ECOLOGICAL VANDALISM

I object to the proposed modification to increase clearing limits on Aarons Pass Road (APR), two of many reasons being **misleading** and **false information** provided by CWP Renewables.

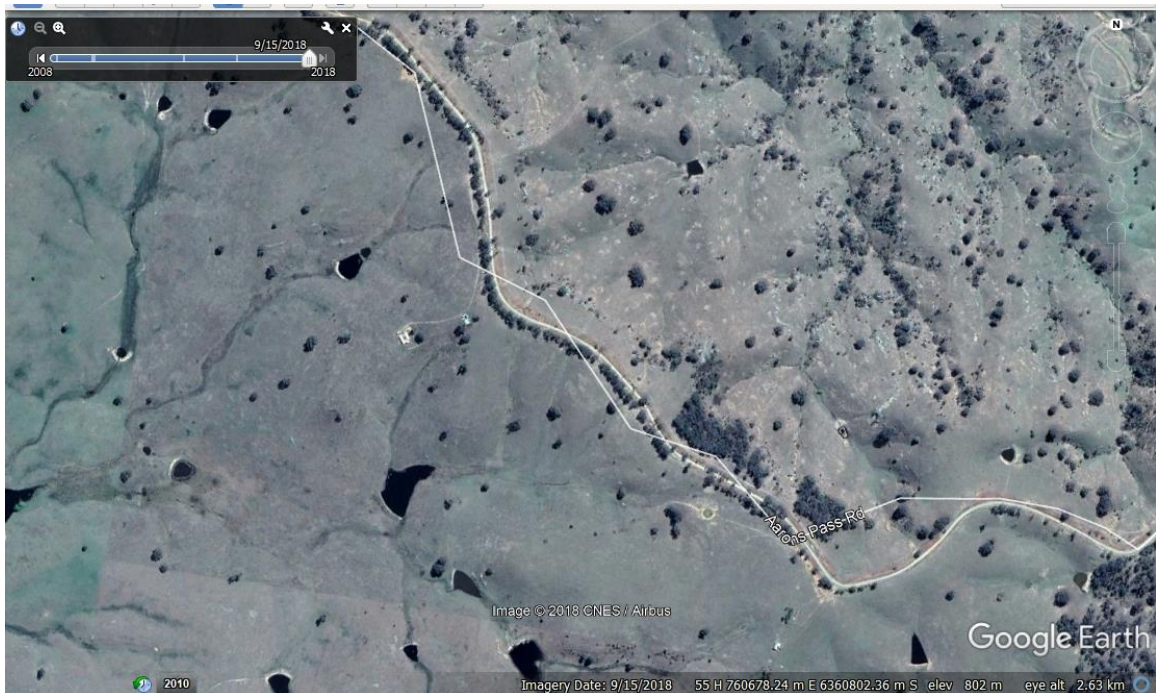
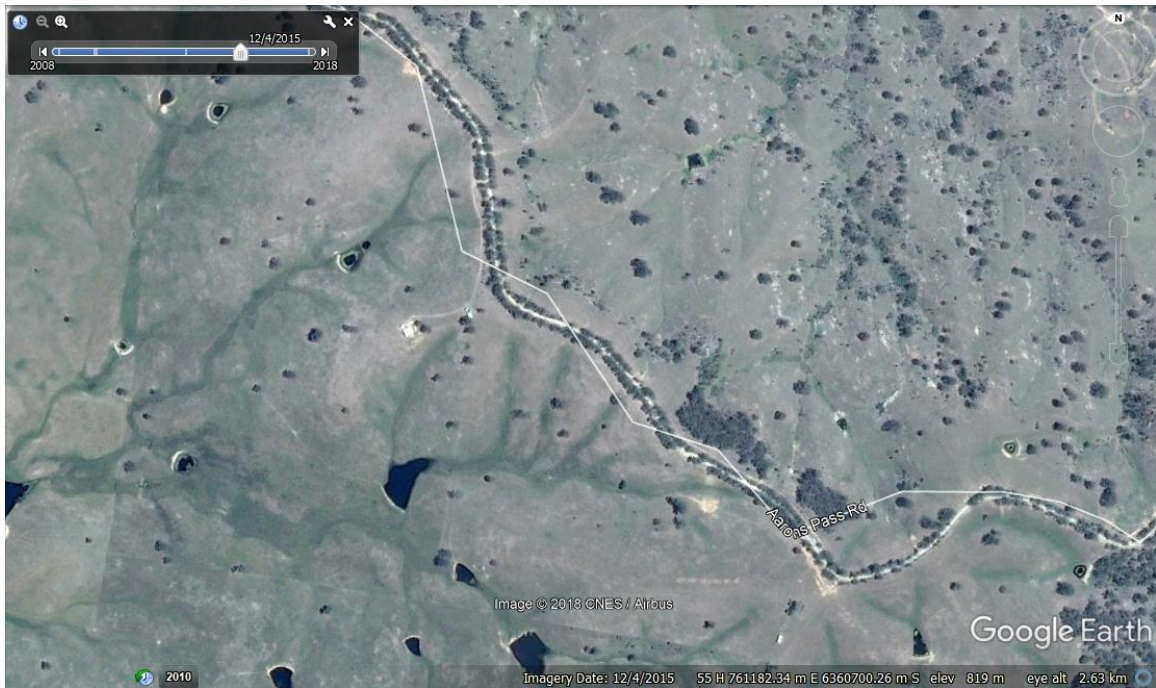
If we assume the developer is correct and we also assume that approximately 5 extra hectares of clearing are required in the remaining 17 kilometers of APR, then the density of clearing to go is approximately **8 times worse** than that already cleared.

Fortunately, from Google Earth, we have before and after images of the clearing in those first 3 kilometers. Take a look below:

And that shows the clearing on the Northern side of the road only. We must assume that they planned to do the same to the Southern side, but were thankfully stopped before this vandalism could be completed.

A clearing density 8 times that of the existing clearance evidence would be impossible to imagine.
